# HISTORIC AND DESIGN REVIEW COMMISSION

Agenda Item No: 11

**HDRC CASE NO:** 2016-084  
**ADDRESS:** 714 N PINE ST  
**LEGAL DESCRIPTION:** NCB 1659 BLK G LOT 5  
**ZONING:** R6 H  
**CITY COUNCIL DIST.:** 2  
**DISTRICT:** Dignowity Hill Historic District  
**APPLICANT:** Sergio Duran/Three Design Consulting  
**OWNER:** Jennifer and Leo Naeger  
**TYPE OF WORK:** Fenestration changes, new addition, porch and garage repairs  
**REQUEST:**

1 WEST ELEVATION

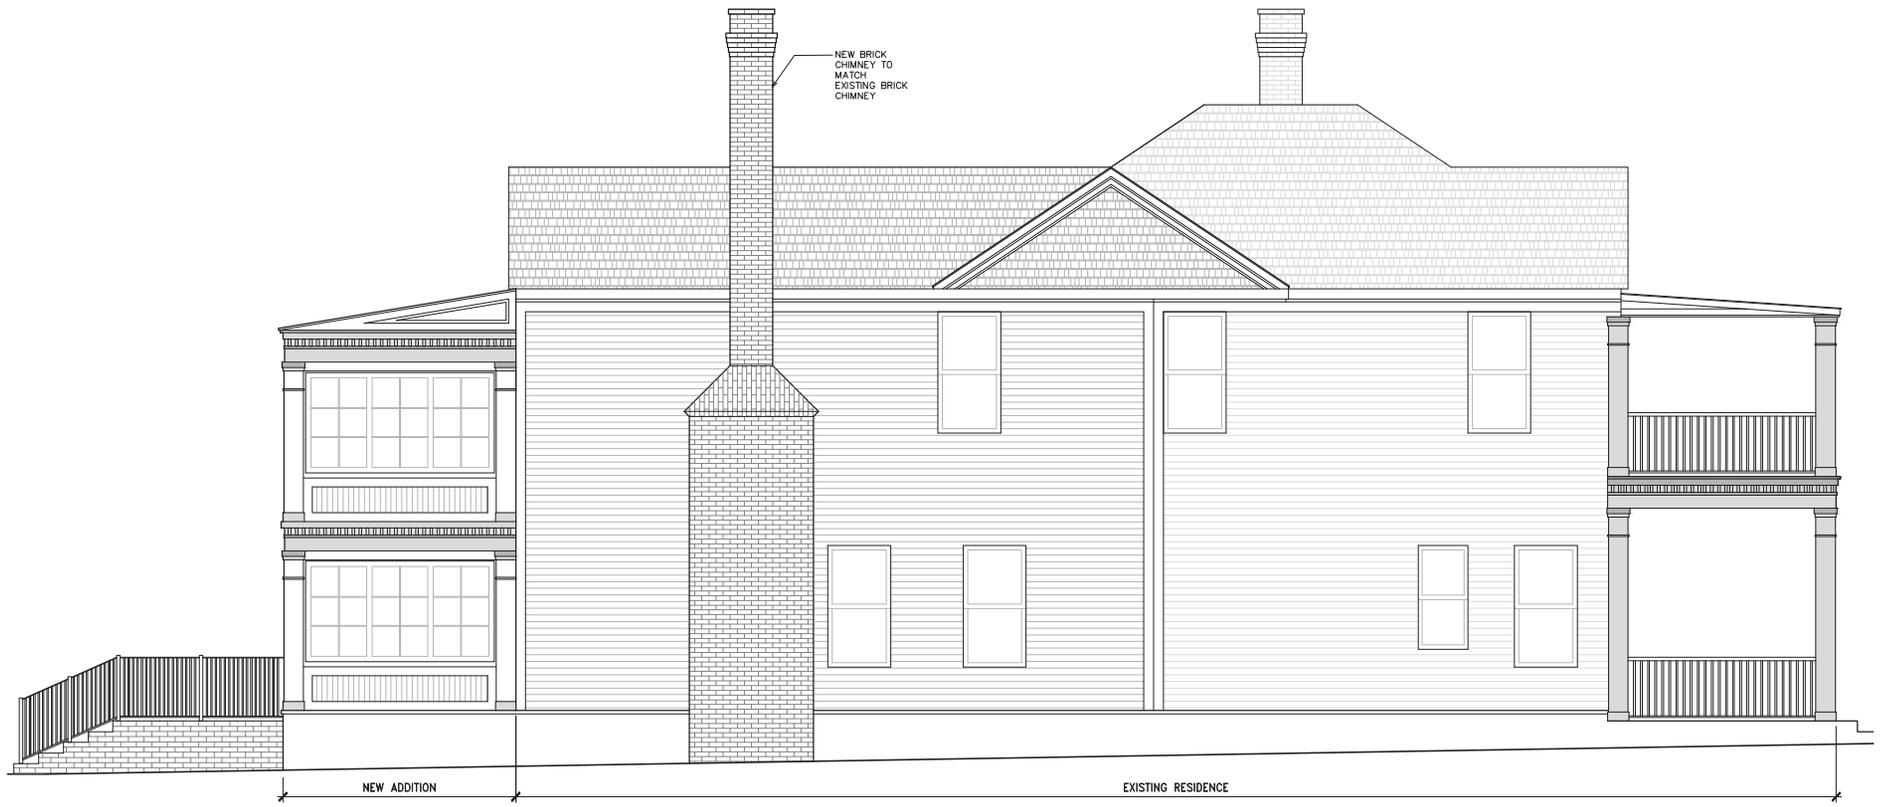
COMMENTS/CONCERNS: MA - Porch detailing is appropriate  
Columns added to porte cochere; need to see west elevation  
Comfortable w/ location of the porte cochere. Recommends  
a 4' fence in front instead of 5'.

1 COLUM/ENTABLATURE DETAIL

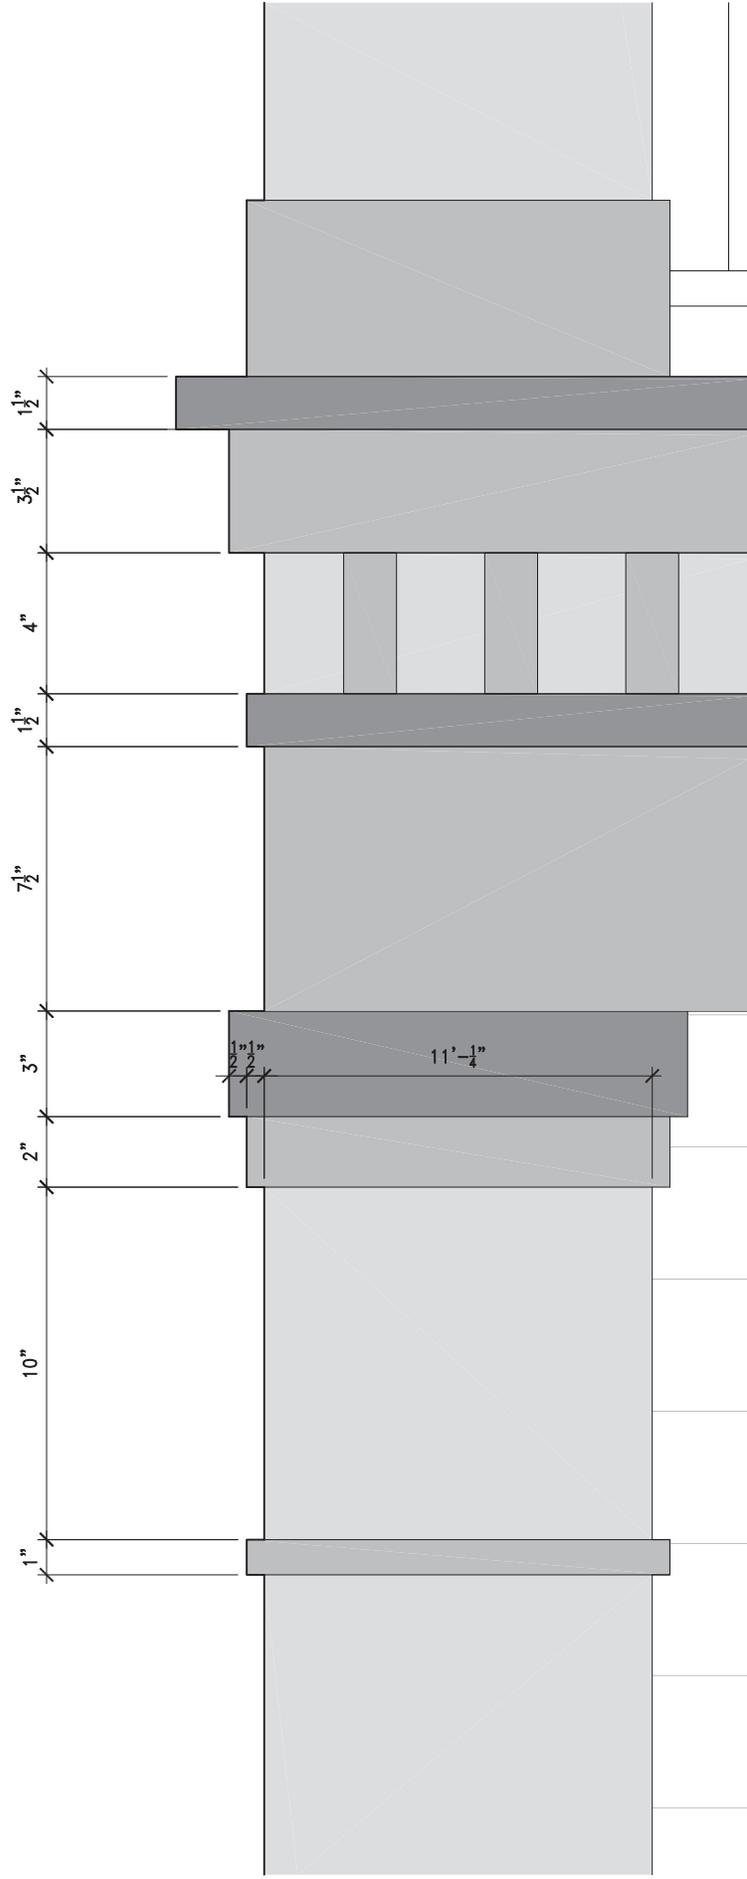
- b. The Design Review Committee met to review this request on May 10, 2016. At that meeting, the committee was satisfied with the detailing provided for the proposed porch. The committee noted that the location of the proposed porte cochere was appropriate. The committee also recommended that a four-foot front yard fence be allowed. Design issues related to the chimney form have also been resolved.
